Subject: KINGSFORD LOCAL STRUCTURE PLAN AMENDMENT NO. 3 TABLE OF MODIFICATIONS – SWAN-SP/2017/5/C

Please see the table below outlining the modifications in the tracked changes document for amendment no. 3 of the Kingsford Estate Local Structure Plan.

PROPOSED MAP

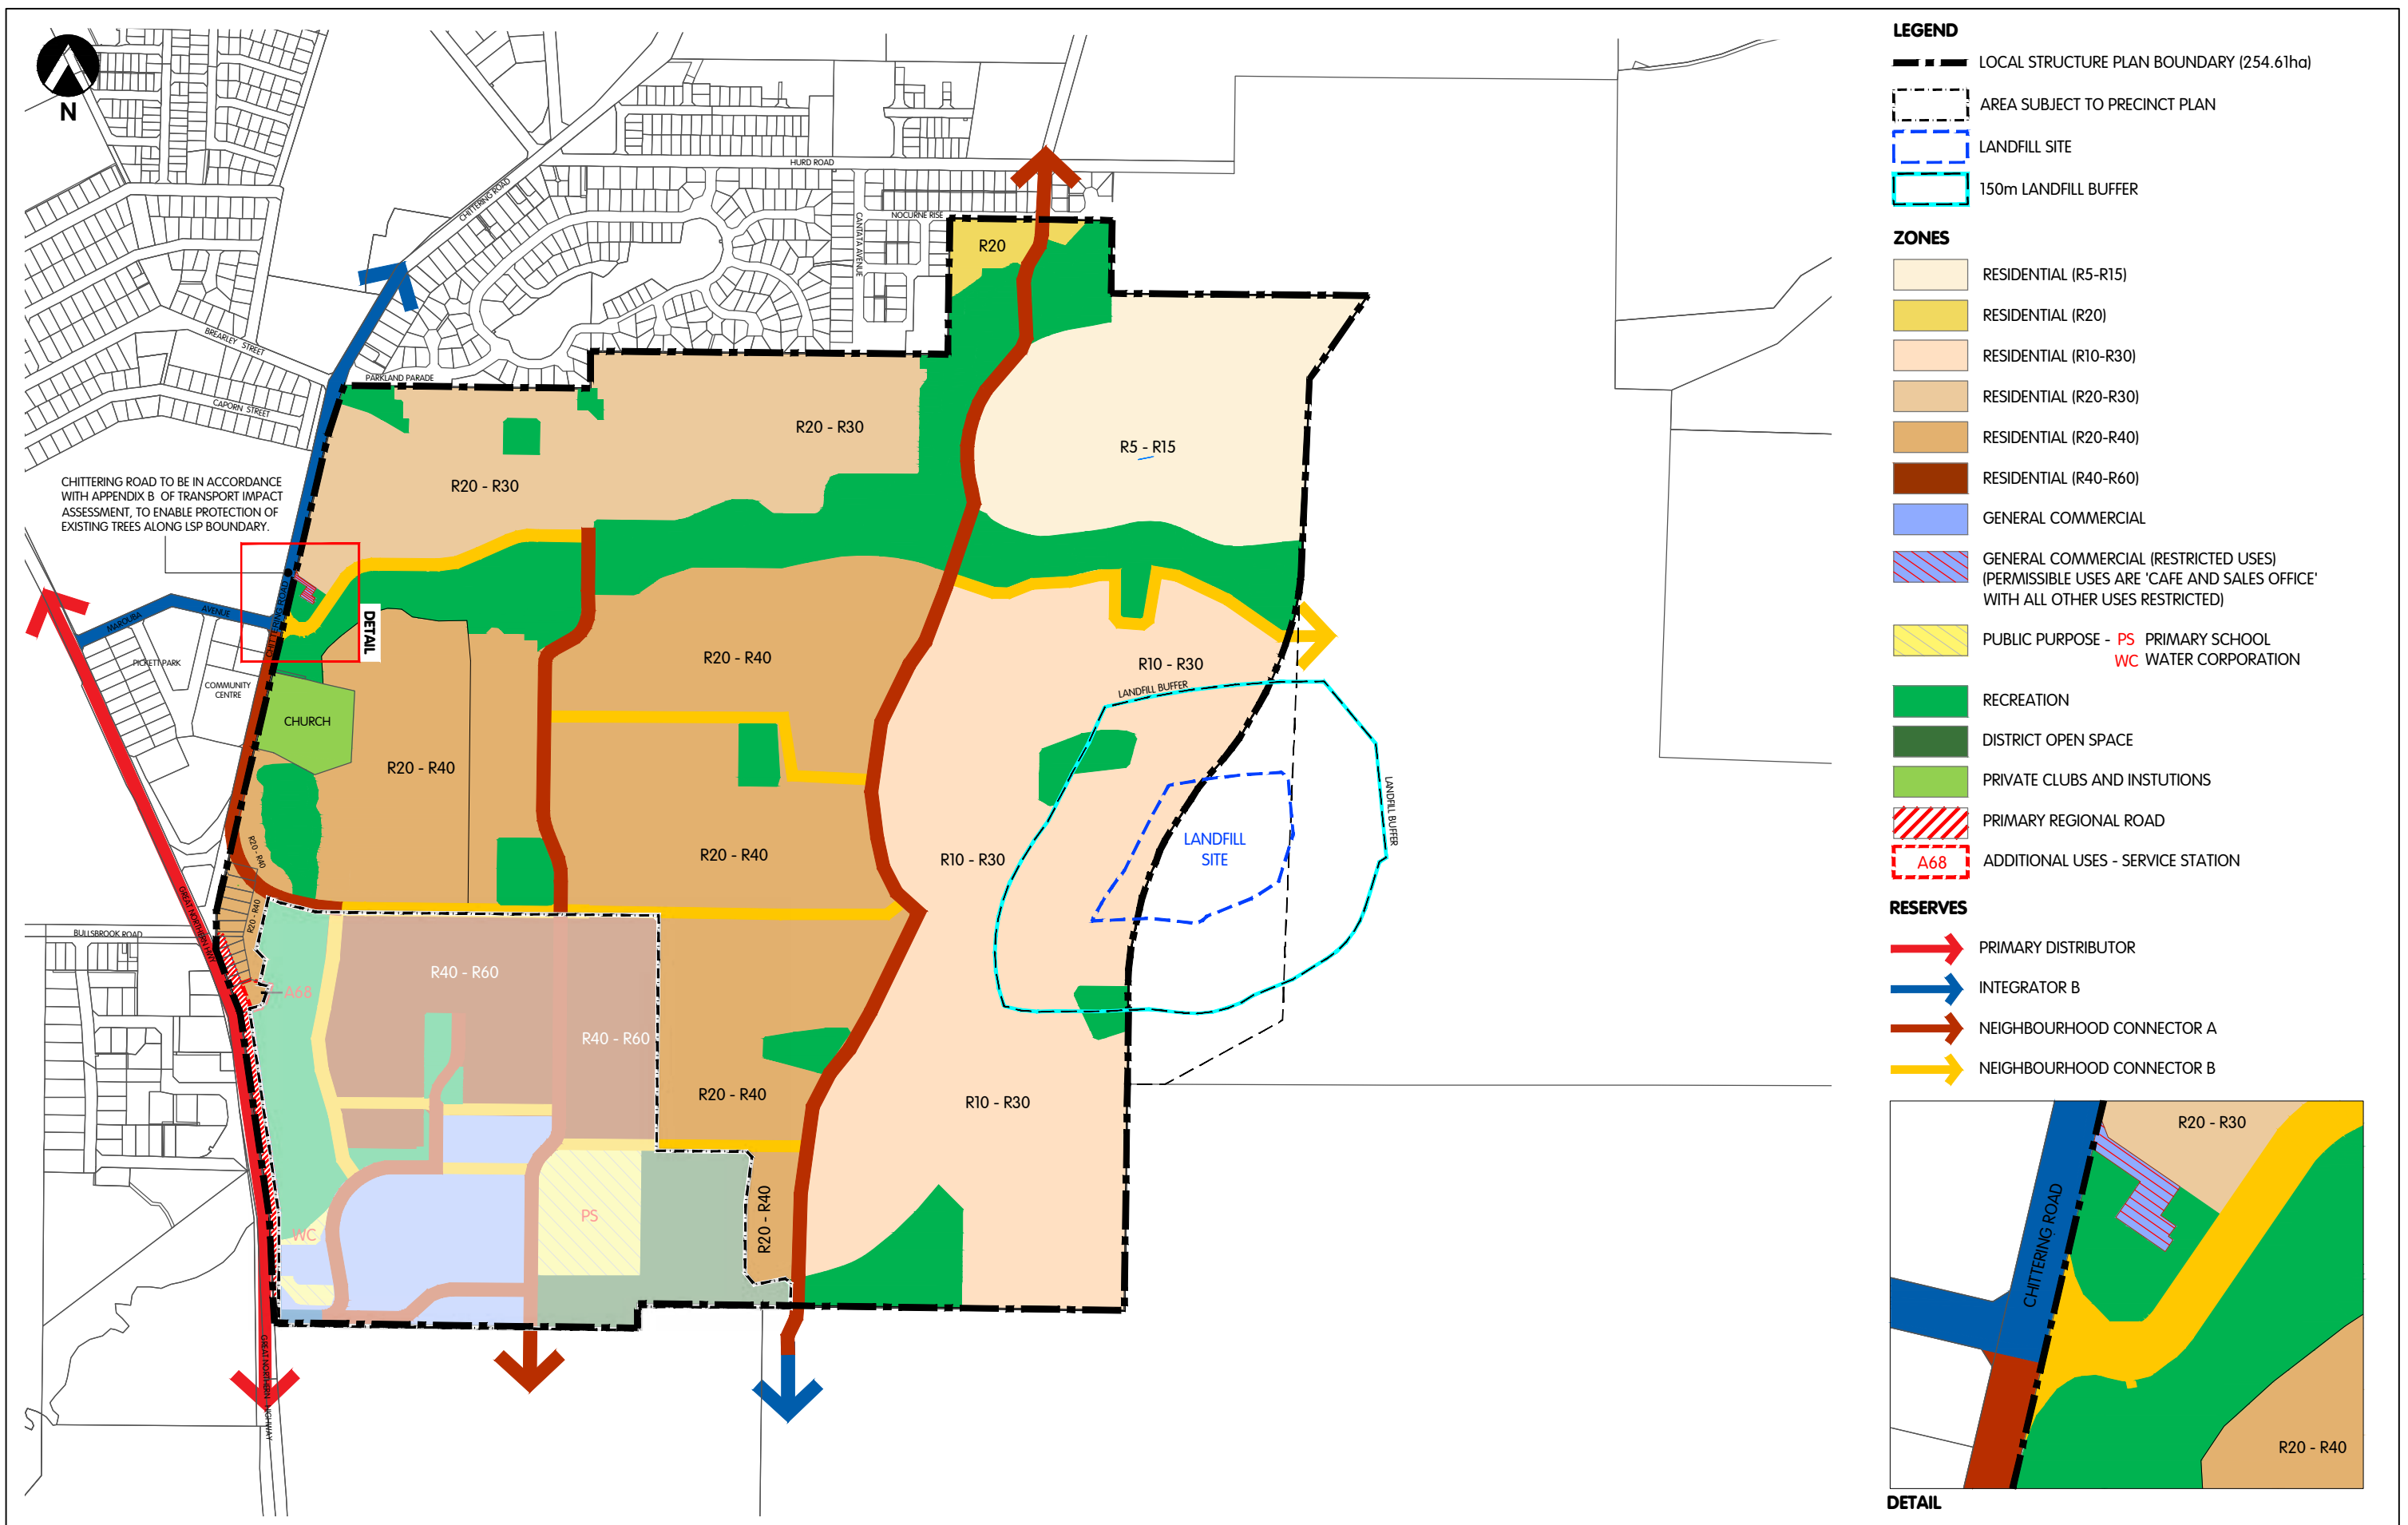
Amendment No.	Part	Page	Proposed Modification
1	Part One	11	Update text to specify the minor modifications of the reduced landfill buffer. The following text will be included: <i>Proposed Amendment No.3 provides for a formal referral to be sent to DWER to comment on the current 500m buffer as imposed by the WAPC.</i>
2		13	Update text to specify the minor modification in relation to future residential subdivision: <i>Approval of proposed Amendment No.3 by the WAPC, with support from DWER will reduce the landfill buffer and allow for subdivision approvals to be issued up to 150m from the now closed landfill facility.</i>
3		16	Update Plan 1 (Structure Plan map) to reflect the following specific modifications: Reduced landfill buffer from 500m to 150m
4	Part Two	40	Update Part Two – Explanatory section to include the section 4.5 Landfill Buffer whereby the text will be included as follow: <i>The WAPC in September 2024 endorsed the Kingsford Bullsbrook Central LSP (Amendment No.2) which imposed a 500m buffer in response to the landfill facility being a prescribed premises under Part V of the Environmental Protection Act 1986. (Licence L9162 / 2018). No residential subdivision was permitted within the 500m buffer.</i> <i>DWER in consultation with the Department of Health in letter of 7th August 2025 identified Lot 903 as containing the landfill facility including waste sorting and backfilling of former clay quarry pits. As a result of partial site</i>

<i>investigations Lot 903 was to be classified as ‘possibly contaminated – investigation required’.</i> <i>As a result of further liaison with DWER on the nature of the landfill activities and extent of works, the classified area of Lot 903 was reduced and reflected in an ‘Interest Only Deposited Plan’ (IODP). The IODP now identifies the relevant portion of Lot 903 where potentially contaminating activities may have occurred with an associated buffer.</i> <i>The IODP classification area represents the likely or potential contamination risks from the landfill site and incorporates a buffer of at least 150m to the west of the facility footprint towards the areas undergoing residential development in the Kingsford estate.</i> <i>DWER have confirmed the IODP includes the prescribed premises and immediately surrounding areas which are subject to ongoing site investigations for the previous landfill facility and the area they will assess for the future works approval to undertake capping of the landfill site.</i> <i>The current 500m buffer has been implemented by the WA Planning Commission. DWER can only provide comment on the proposed reduced buffer if the WAPC / City of Swan lodge a formal request for comment.</i>
